JJ RANCH SUBDIVISION

BEING A PART OF THE SOUTHWEST QUARTER OF SECTION 14,
TOWNSHIP 11 SOUTH, RANGE 65 WEST OF THE 6TH PRINCIPAL MERIDIAN,
COUNTY OF EL PASO, STATE OF COLORADO.

PDC File No: SF2511

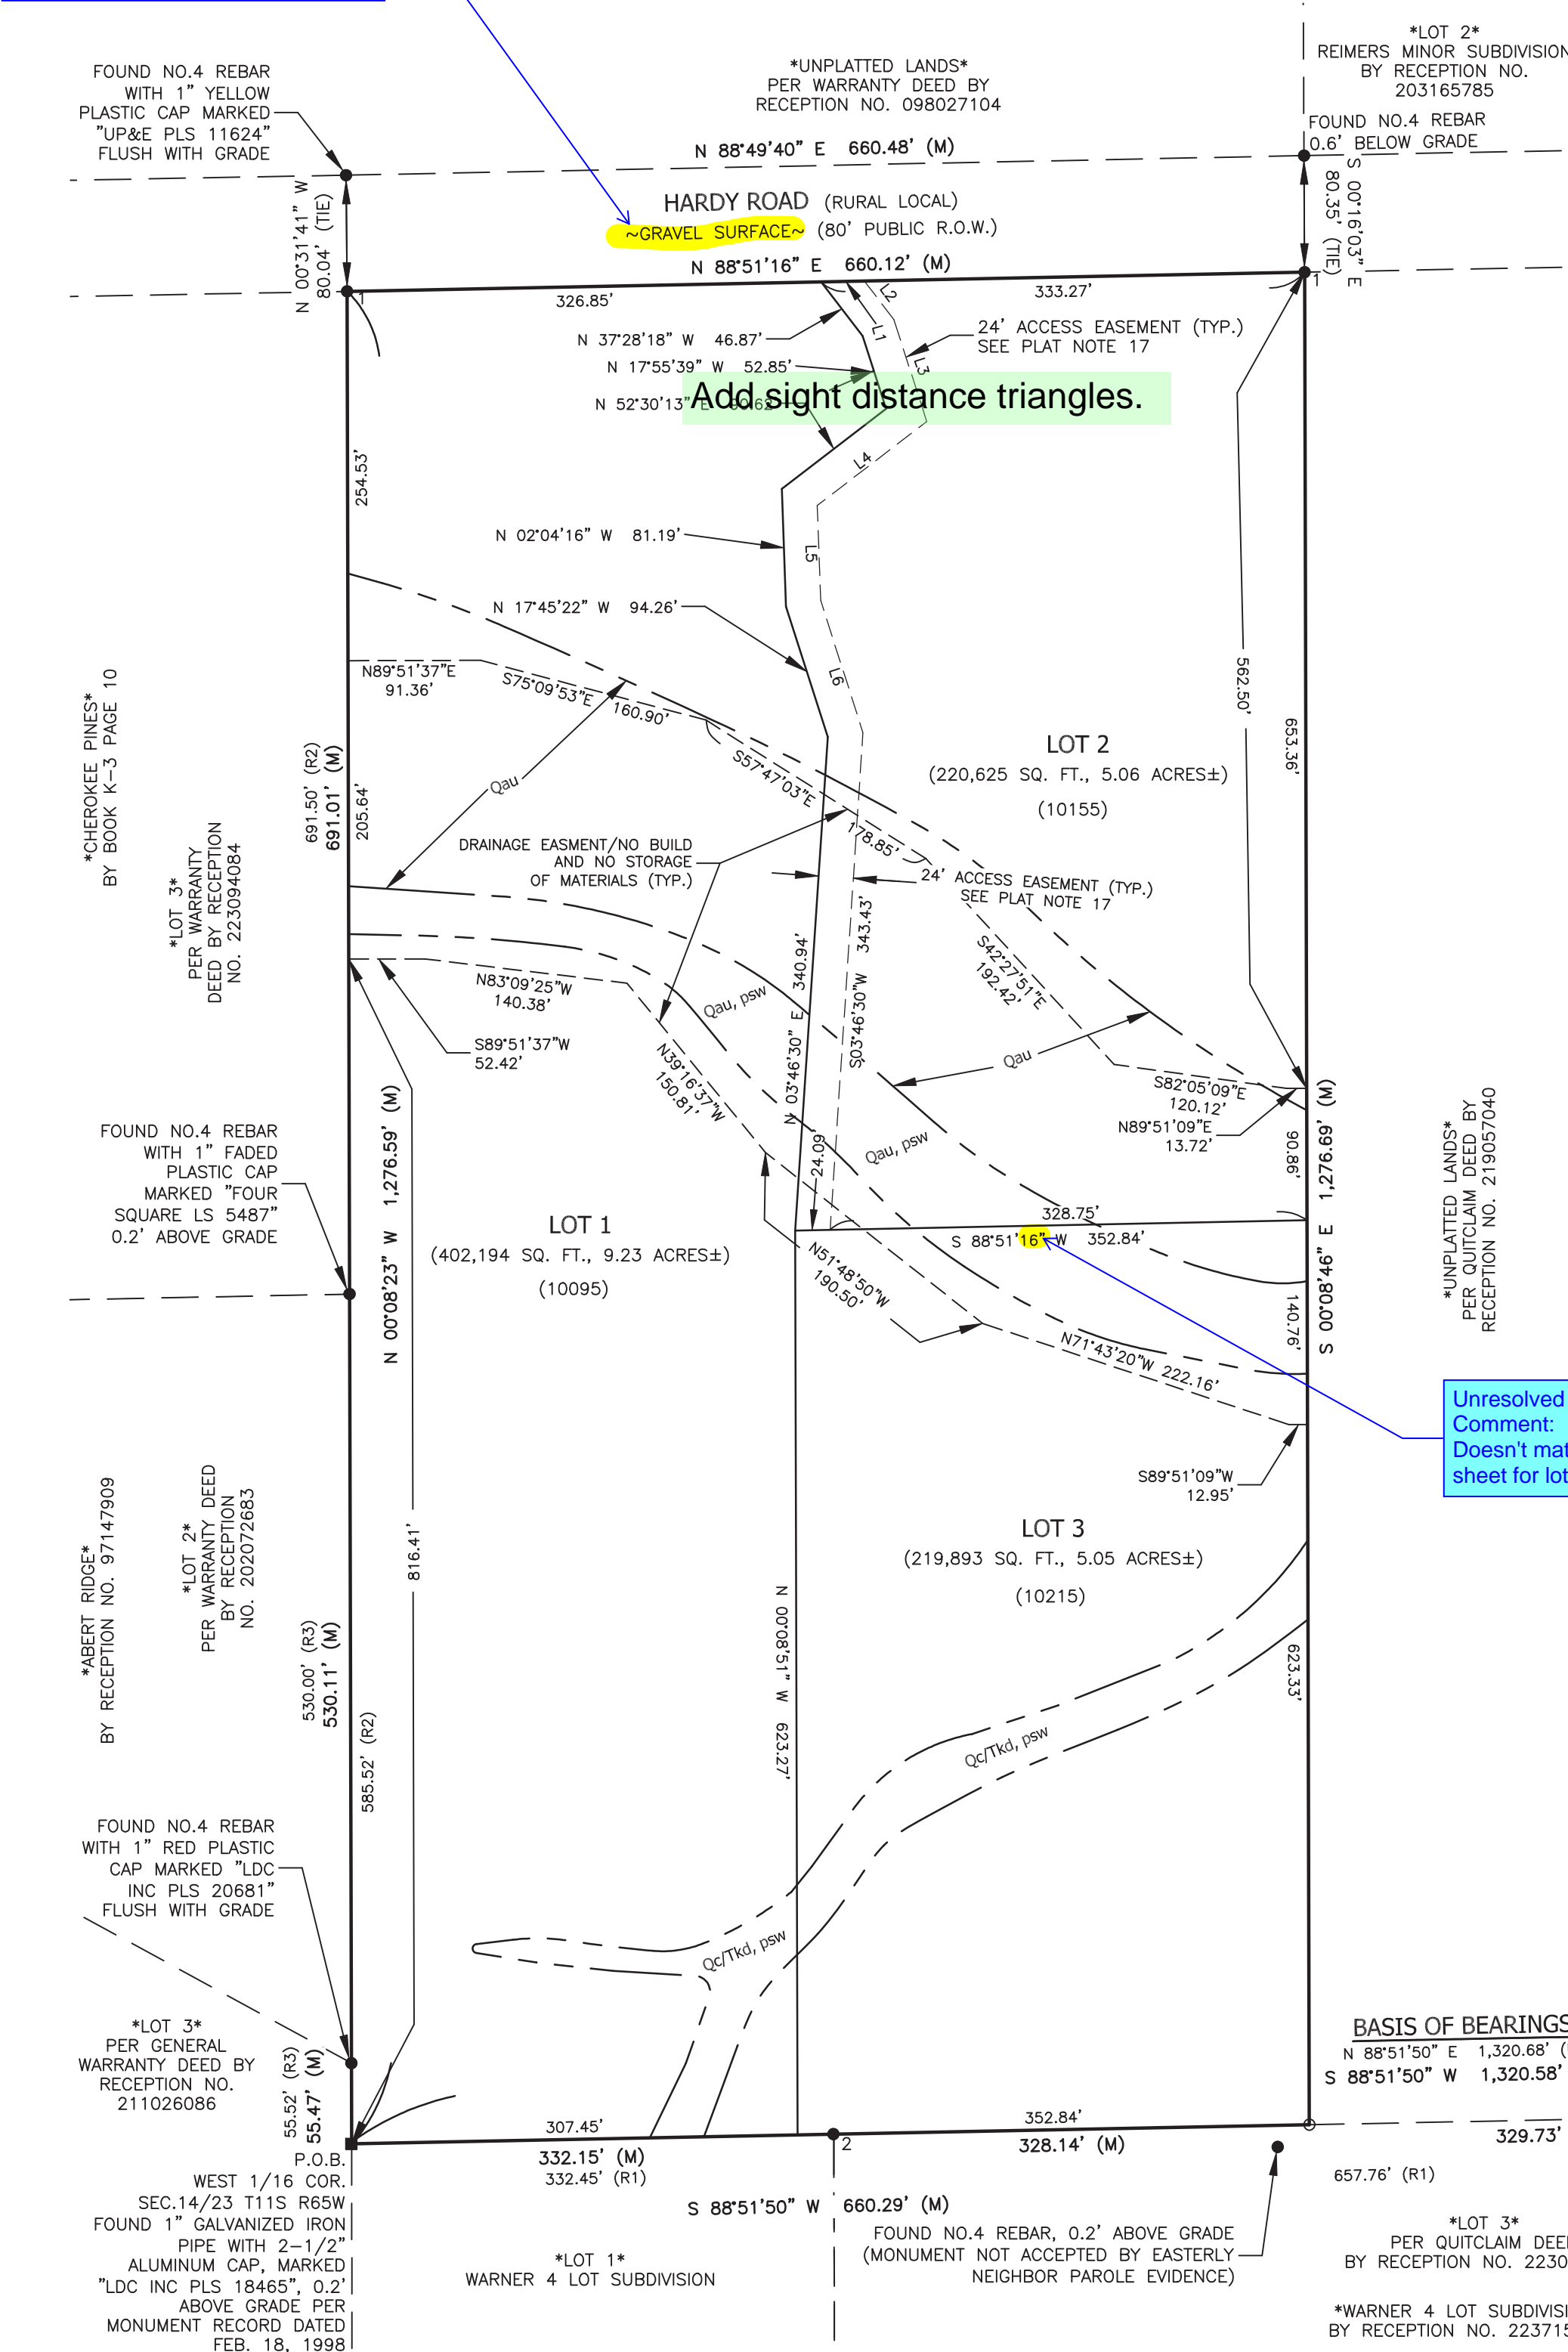
Please not include Road surface
type in plat drawings as this is a
legal document and the road surface
is subject to change in the future.
